CHANGES FROM SCHEME PERMITTED
UNDER ABP-307415-20 - ROOF LEVEL

PROPOSED
ROOF PLAN

Project		RESIDENTIAL APARTMENTS, LISIEUX PARK		6-7 HARDCOURT TERRACE, DUBLIN 2, IRELAND	
Drawing Title		Murphystown Road, leopoldstown, Dublin 18		1 + 360-1-618 2100 1 + 360-1-678 1385	
Stage		Planning		www.bkd.ie	
Scale		1:200@A1		bkdarchitects	
Project Code		6275		BURKE-KENNEDY DOYLE	
Job		LIS - BKD - 00 - RF - DR - A -			
Zone		1100			
Level		P03			
Type					
Dis					
Sheet no.					
Status					
Rev					
Date		23.05.2022

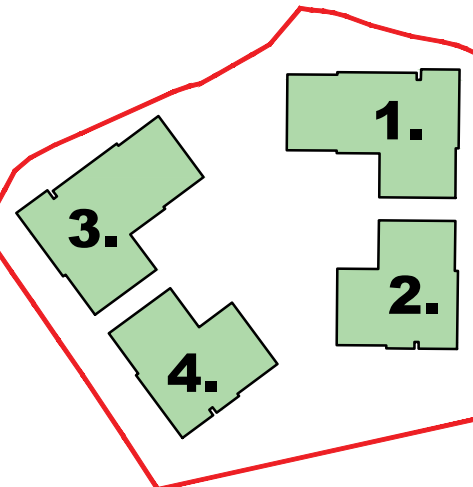
BLOCK 1 ROOF: 2 ADDITIONAL SMOKE
CONTROL AOV'S AND 1 LIFT OVERRUN
ADDED TO COMPLY WITH REQUIREMENTS OF
FSC.

36 LOW-PITCH PV PANELS ADDED FOR
COMPLIANCE WITH BUILDING REGS PART L

GLAZED ATRIUM REMOVED ABOVE STAIR
AND LIFT CORE
